IN THE MATTER of a Private Plan Change to the Matamata-Piako District Plan under Schedule 1 of the RMA by Rings Scenic Tours Limited to introduce a Development Concept Plan, to enable the ongoing operation and growth of tourism activities at Hobbiton Movie Set within an appropriate planning framework

STATEMENT OF EVIDENCE OF ALASTAIR BLACK

Dated 9 April 2019

Figure 1: Diagram of Conflict Modelled use for 385 and 399 Buckland Road

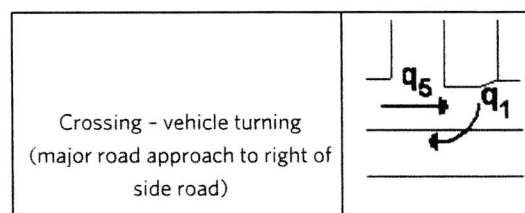
54. As these vehicle crossings fall outside the applicable flow ranges and have visibility deficiencies I now prefer to rely on the conflicting flow models in the NZTA's Crash Estimation Compendium (First Edition, Amendment 1, effective from 01/06/2018) which should more accurately reflect the crash risk. The following assessment only considers crashes resulting from the crossing/turning movement shown below.

55. The following table replaces the assessment of the predicted injury crash rate presented as Table 6 of my Updated Transportation Review (2019). It is based on sight distance required for a design speed of 80km/h. In summary:
- The proposal increases the predicted injury crash rate by 12%;
 - Lowering the road by >2m to achieve SISD reduces the predicted injury crash rate by 300%; and

- (c) Lowering the road by approx. 0.9m achieves 114m SSD (but does not achieve SISD) and reduces the predicted injury crash rate by 50%.
